ADDENDUM NO. 3  
SEWER SYSTEM IMPROVEMENTS  
CONTRACT 17-01  
SOUTH WWTP AERATION BASIN IMPROVEMENTS  
HENDERSON WATER UTILITY  
HENDERSON, KENTUCKY  
WAUFORD PROJECT NO. 2077

Date of Addendum: Wednesday, July 12, 2017

△ AIR HEADER DETAIL

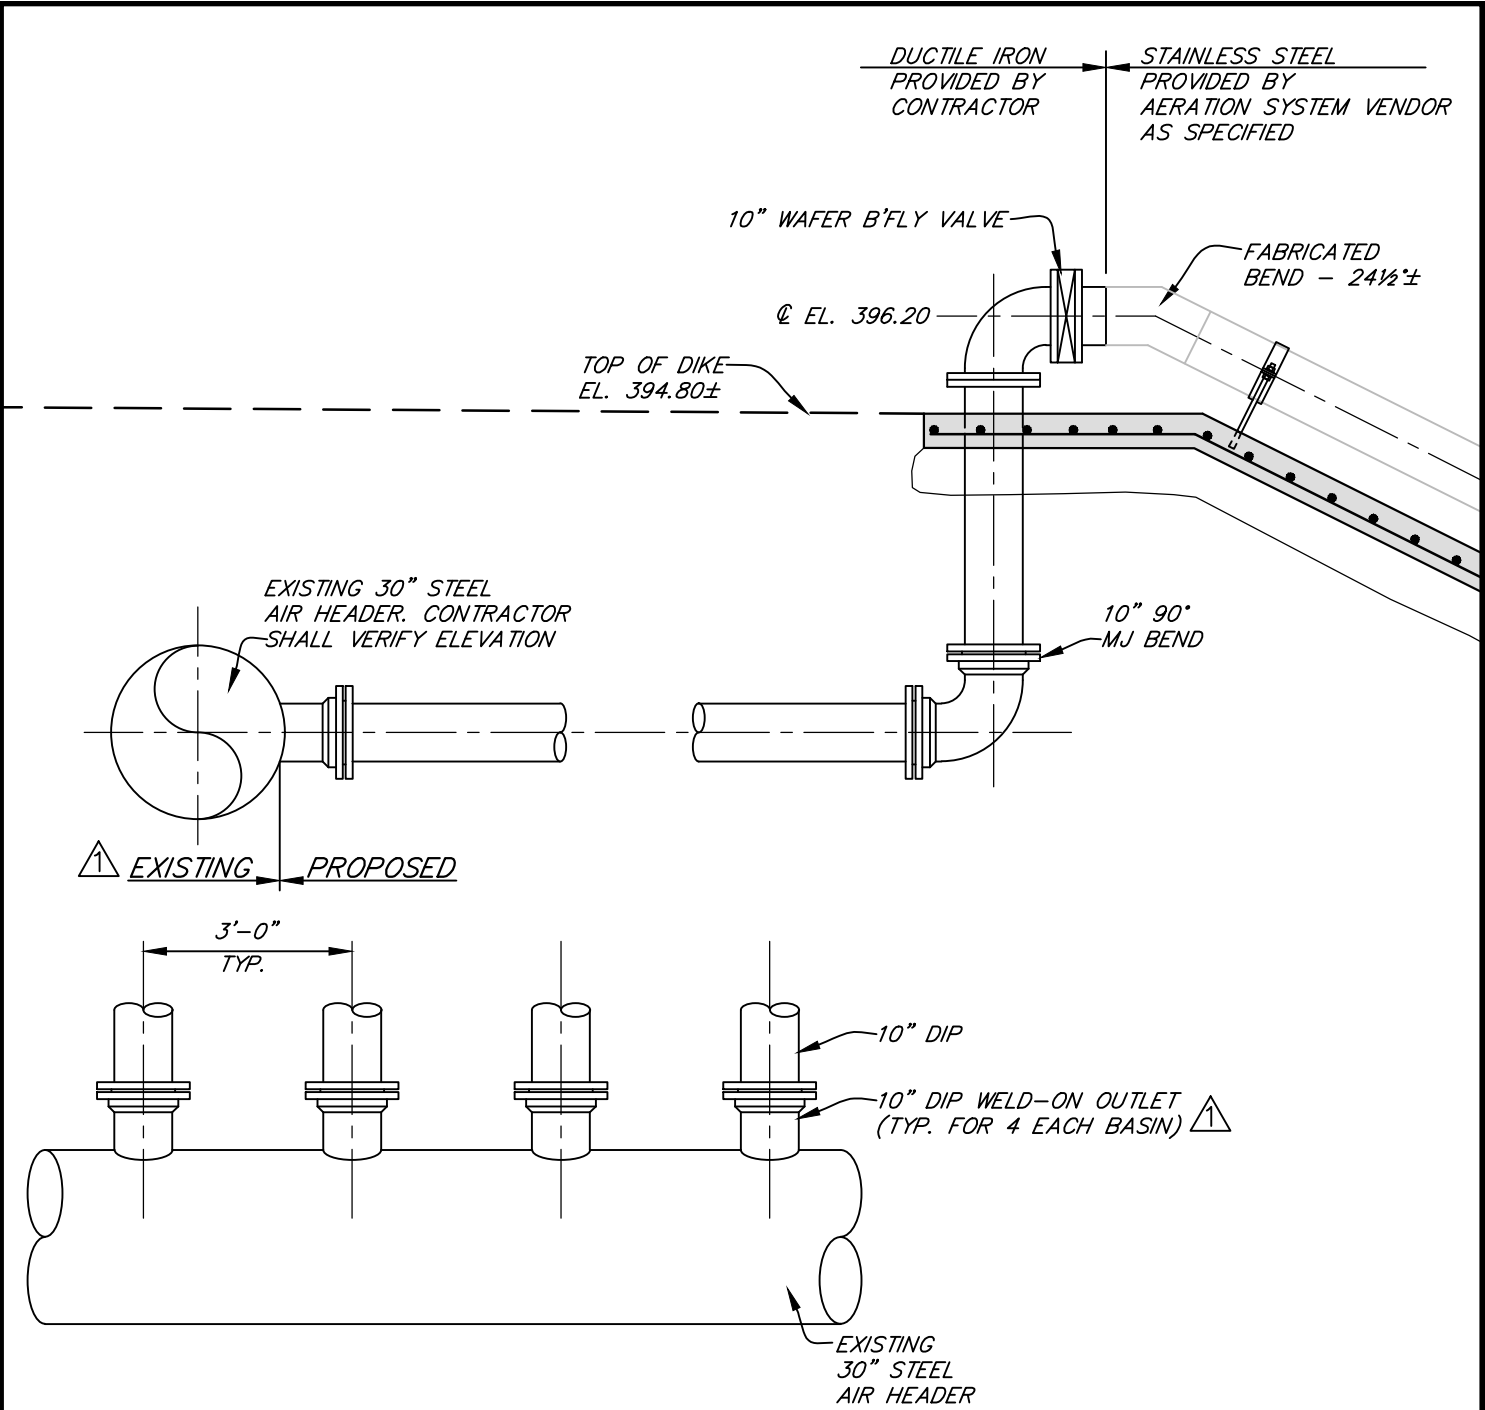
3. Plans, Sheet 6:

Modify as shown on the attached 8 1/2" x 11" sheet.

### GRAIN SIZE DISTRIBUTION

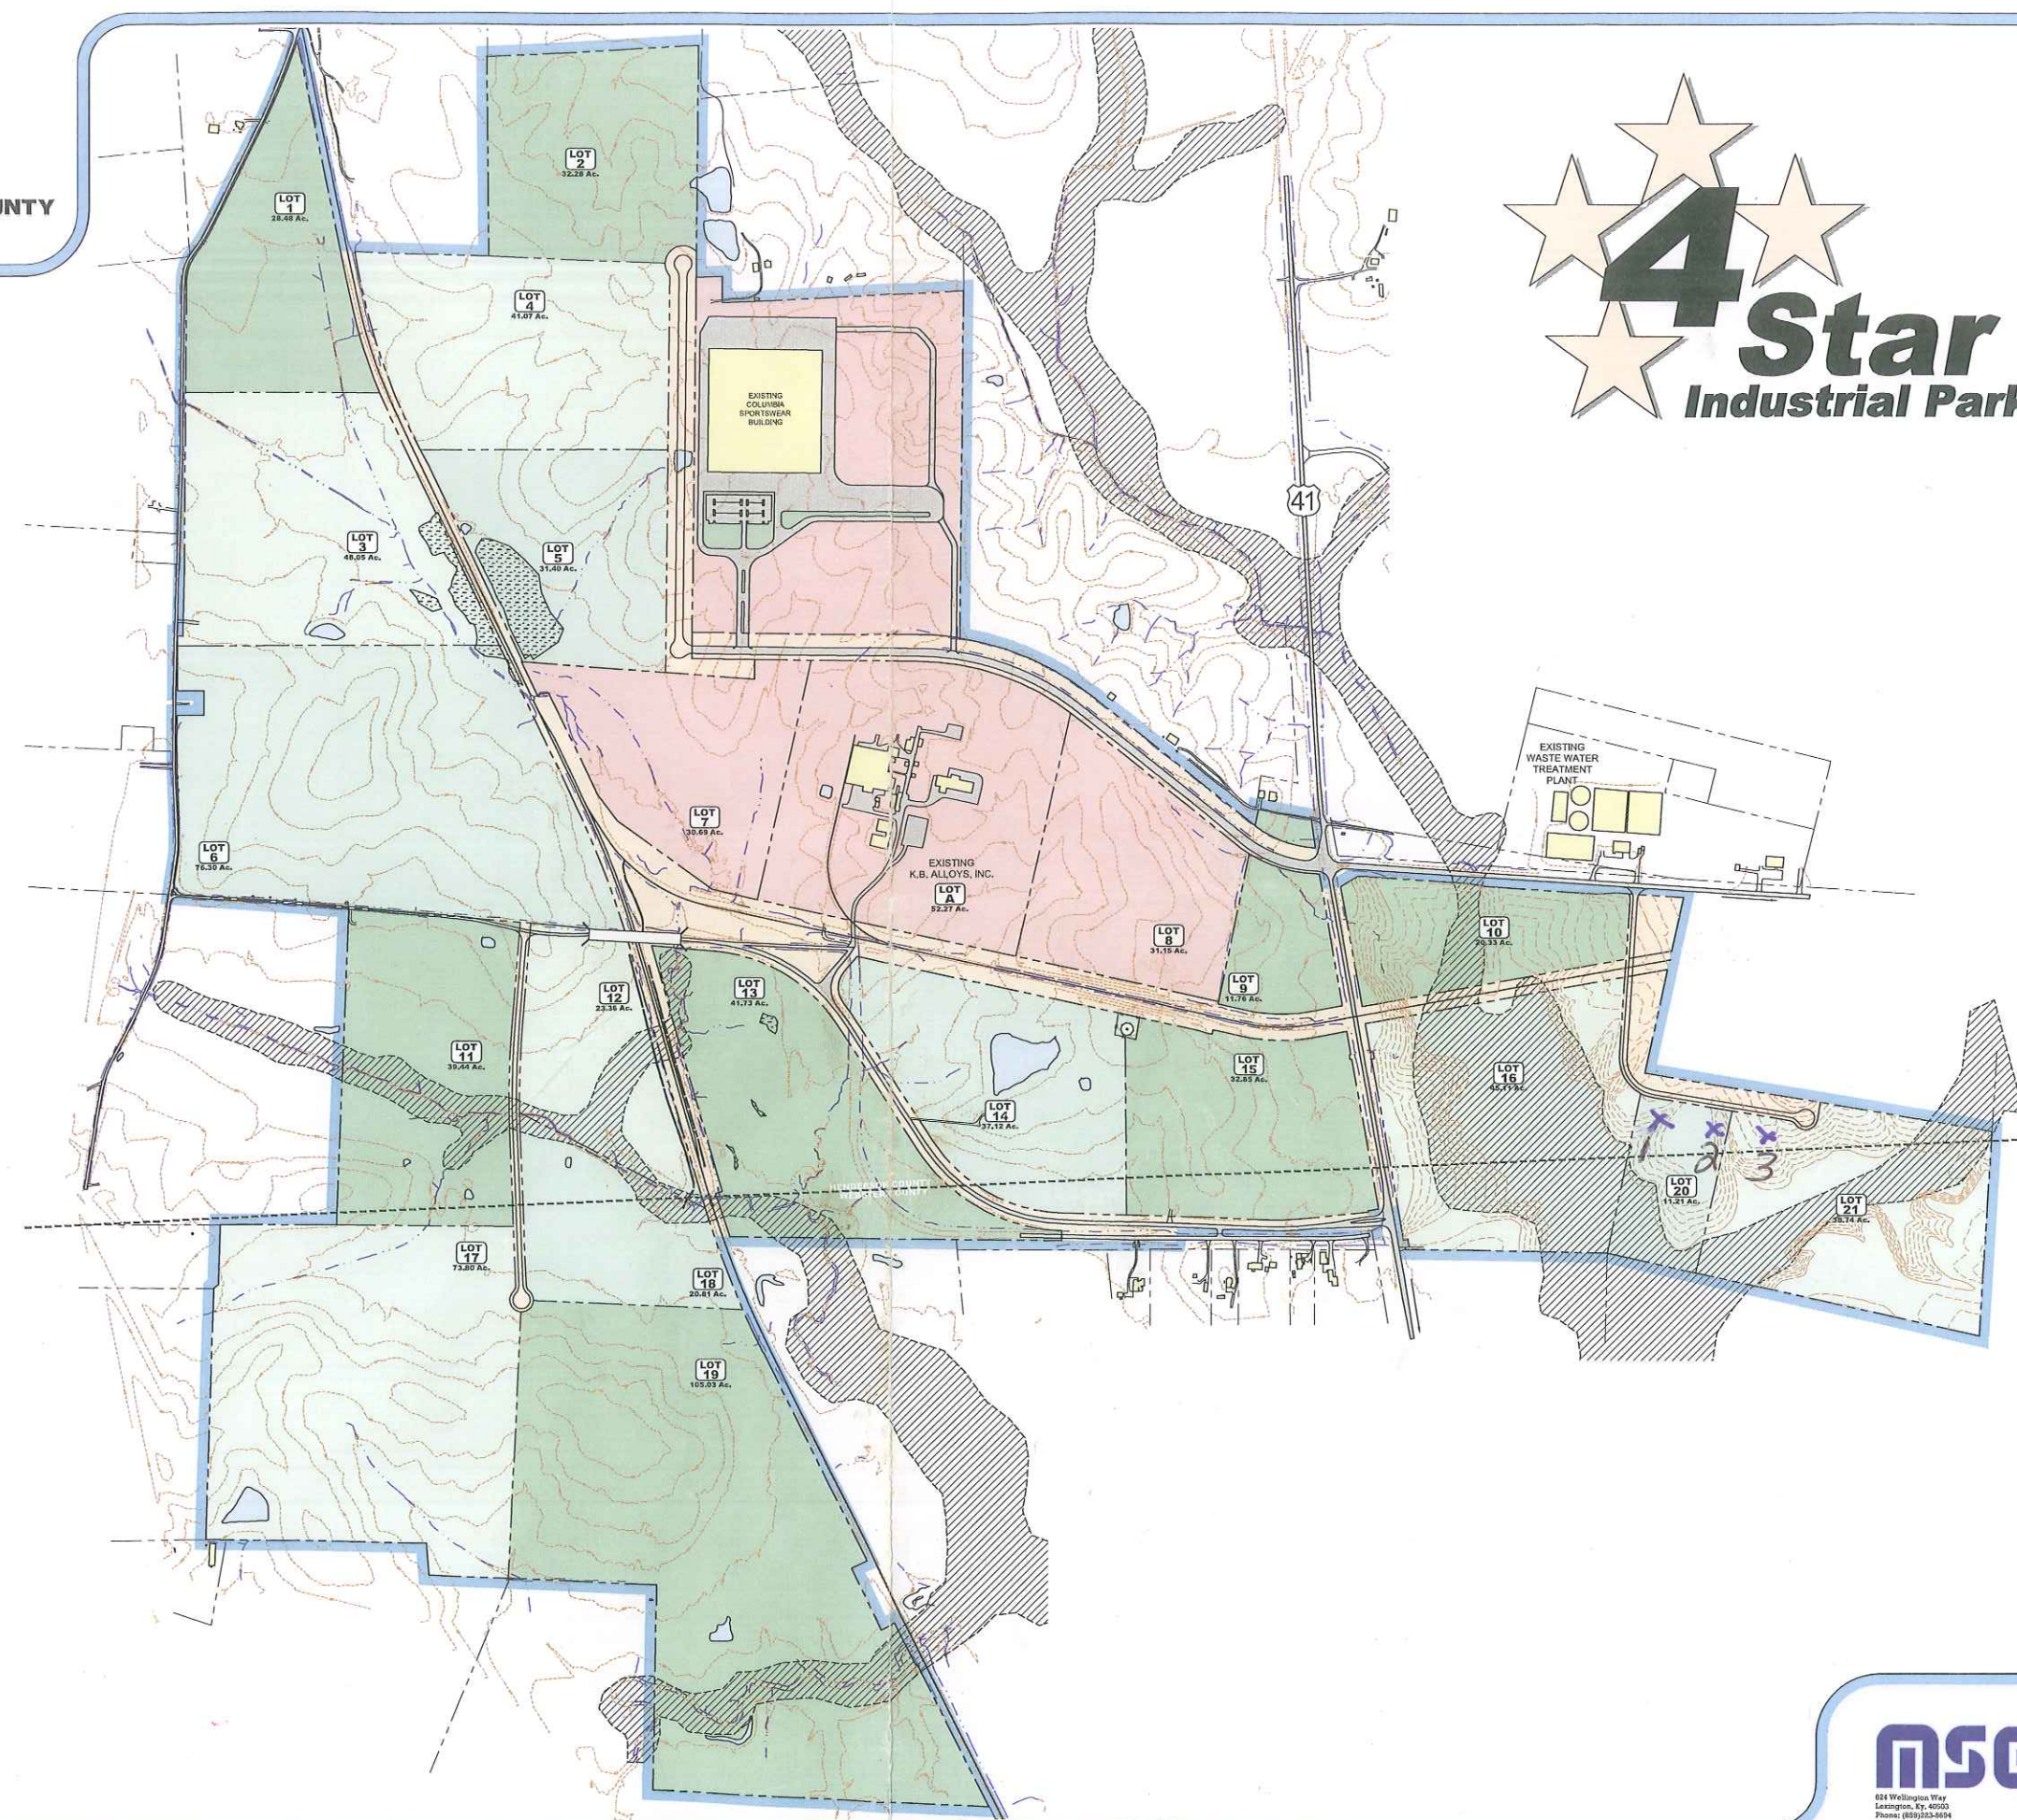
Attached is a graph providing the grain size distribution of three samples of soil that were delivered to our laboratory along with a drawing we were provided showing the locations from which the three samples were taken. Sample 2 has a lower silt and clay content than the other two samples. None of the samples are plastic.

Soil matching that of samples 1 and 3 will work better than that matching sample 2 since the higher silt and clay content will hold the soil on the slope better.
